**ADDENDUM # 2**

**RFP # 7550249**

**TITLE: CONSTRUCTION OF NEW WILDLIFE CENTER, EXETER**

State of Rhode Island Department of Administration Division of Purchasing RFP# 7550249  
CONSTRUCTION OF THE ARCADIA NATURAL RESOURCE VISITOR CENTER, DEM

INTERIOR ELEVATIONS & DETAILS

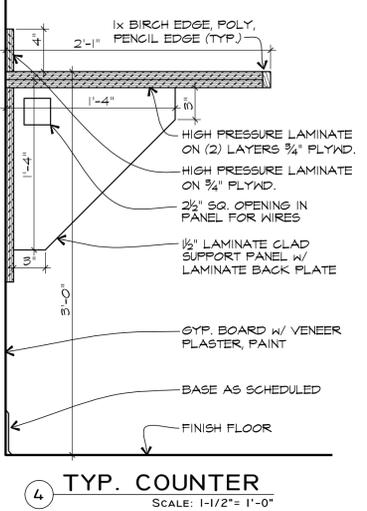
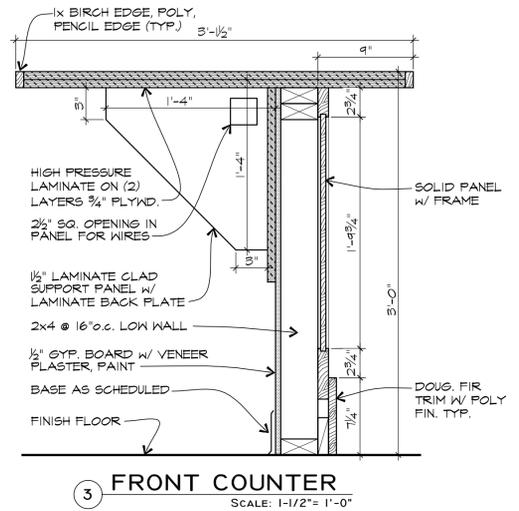
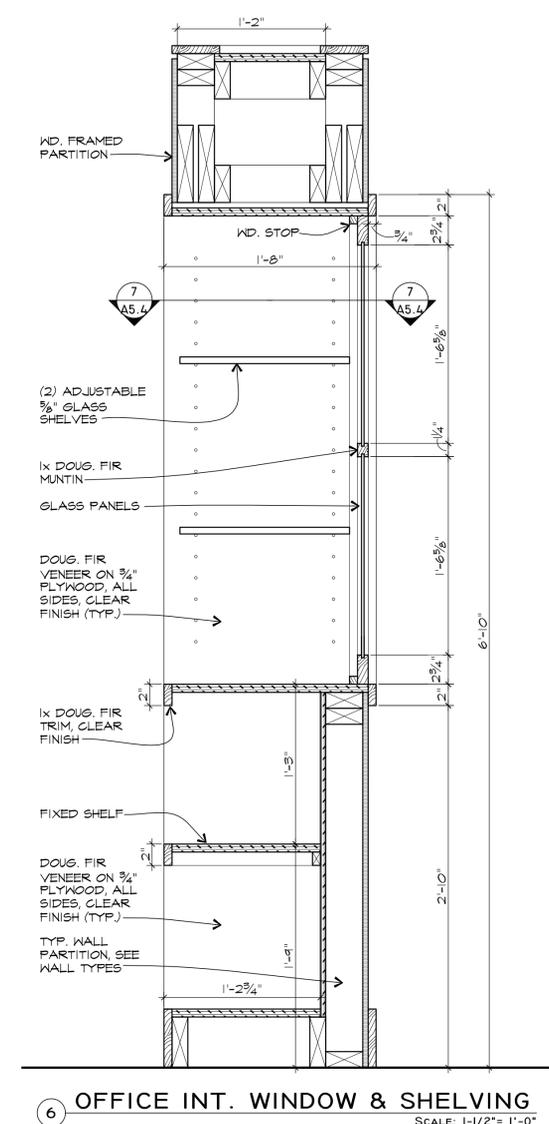
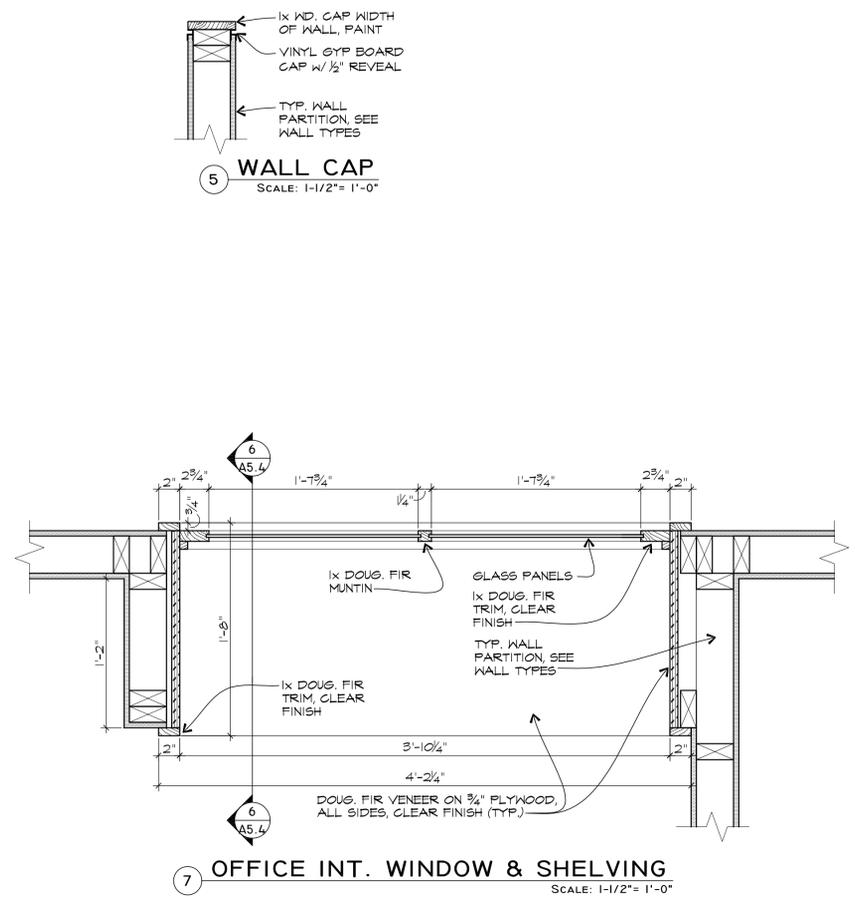
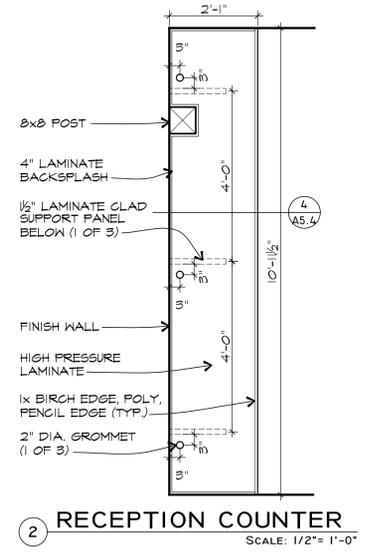
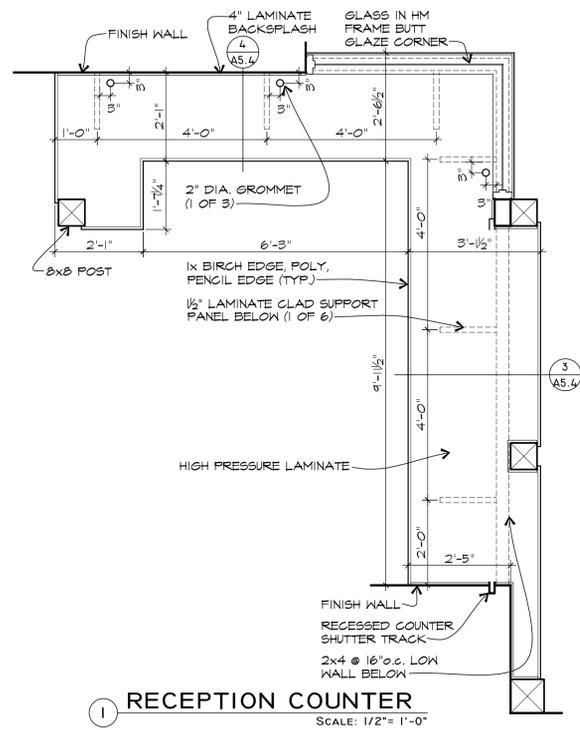
**DRAWING A5.4 INTERIOR ELEVATIONS & DETAILS**, Remove sheet and replace with attached drawing A5.4 INTERIOR ELEVATIONS & DETAILS.

9. Typical Office interior elevation 2-5/A5.3 show an interior window as scheduled with counter. Please furnish details of window and counter identifying frame material, glazing and counter material. Please clarify Section 4/A4.5 showing window, counter and something below counter.

**Response: Interior window and casework details have been added to sheet A5.4 INTERIOR ELEVATIONS & DETAILS. See Addendum Two**
